2010 Edition of ASCE 7
Minimum Design Loads for Buildings and Other Structures

Errata

Errata posting: January 11, 2011

Revise right-hand column labeled “ASCE 7-10 Section” of Table C26.1-1 as follows:

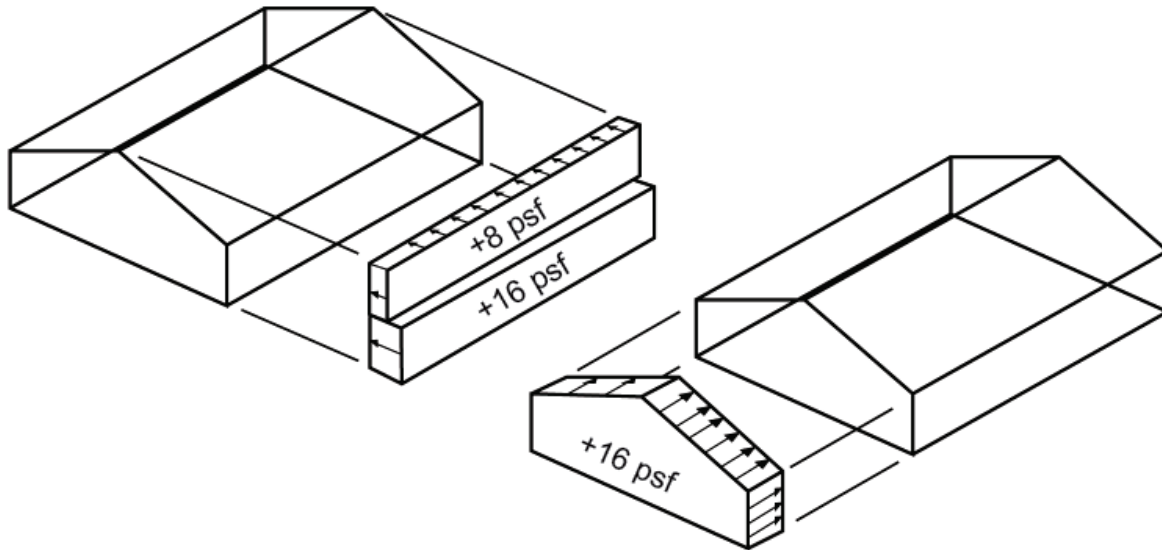
~~29.7~~ 29.6 Parapets

~~30.10~~ 30.9 Parapets

~~30.10.1~~ General Design Procedure
